UPROAR

Technical Notice **ARF**

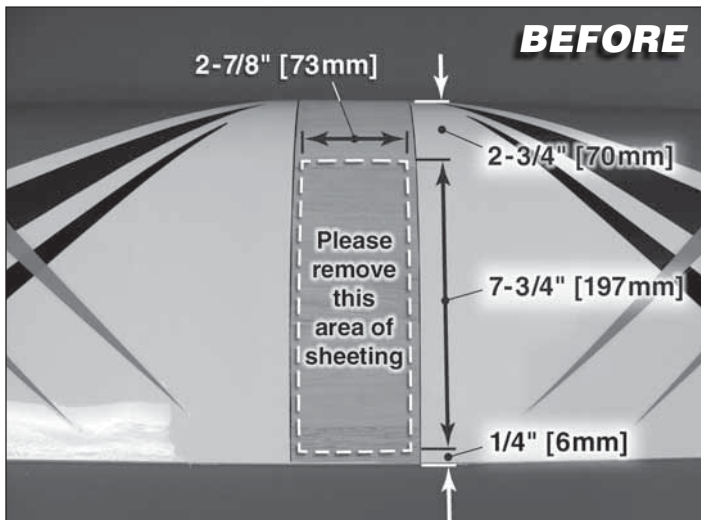
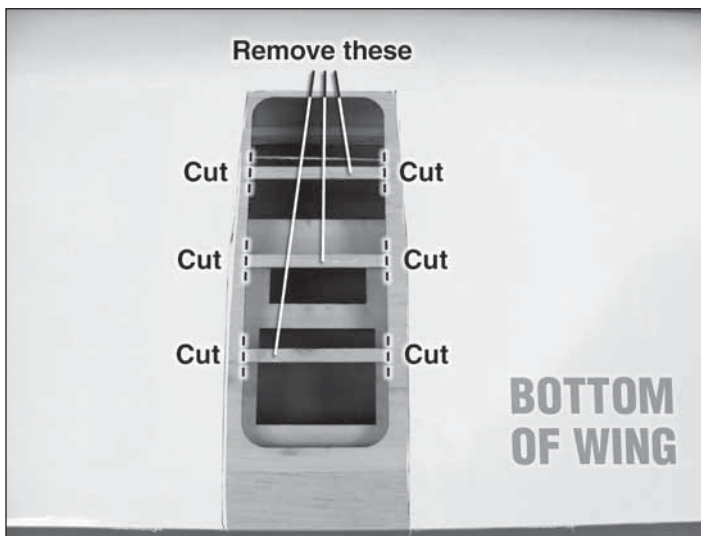
Please follow these additional steps to complete the Tower Uproar.

On Page 7, after completing step 8 it may be necessary to remove the balsa sheeting over the servo tray.

It also may be necessary to remove the cross braces on the bottom of the wing under the covering.
